120V VE.Direct Inverters with GFCI outlet – line/neutral polarity swapped

Technote October 2026

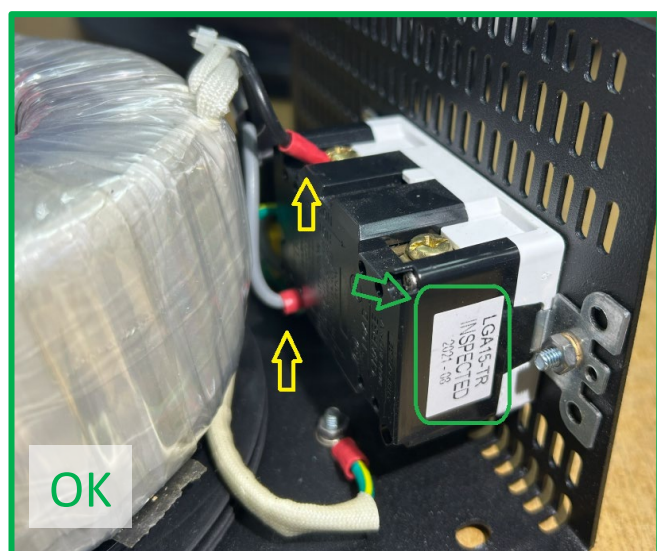
Units with the **previous** type of GFCI outlet are **not** affected. The two types look slightly different, and the easiest way to tell them apart is the label on the side of the outlet (see the picture below).

If the label says **LGA15-TR**, the unit has the previous type of GFCI outlet. On this type the Hot (black) wire is connected at the top, which is correct, so no action is needed. The new type is GF15TR. Note that the Hot and Neutral terminals are in a different position on the two types, so always check the wiring against the terminal markings (HOT WIRE / WHITE WIRE) rather than top/bottom alone.

3. Reconnect the wires to the correct position

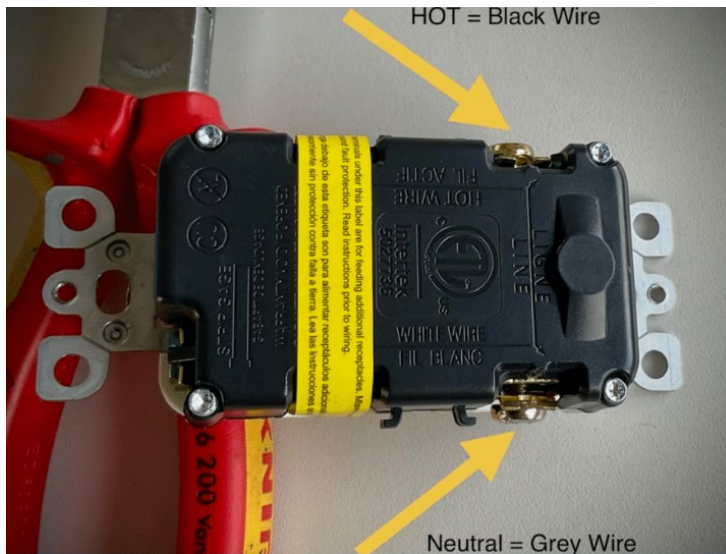
Recent production batches of the 800, 1200 and 1600VA 120V VE.Direct Inverters have an issue with the wiring of the GFCI outlet. The GFCI outlet was recently replaced with a new type and the internal Line (Hot) and Neutral wiring on the back of this new type GFCI outlet are wrongly connected, so that Hot and Neutral are swapped on the outlet. This can make the product unsafe to use.

3. Product level observation: After opening the unit, you can see the internal wire connection on the back of the new type GFCI outlet (GF15TR). With the outlet mounted in the unit as in the images below, the grey wire must be connected on the top side and the black wire on the bottom side: black (Hot) on the LINE terminal marked HOT WIRE, grey (Neutral) on the LINE terminal marked WHITE WIRE.

Black wire (HOT) → LINE terminal marked HOT WIRE

Grey wire (NEUTRAL) → LINE terminal marked WHITE WIRE

Always use the LINE side of the GFCI outlet, not the LOAD side. US wiring uses a white neutral wire; in this inverter the neutral wire is grey.

Max torque setting for the terminal screws on the GFCI outlet: 1.5 Nm
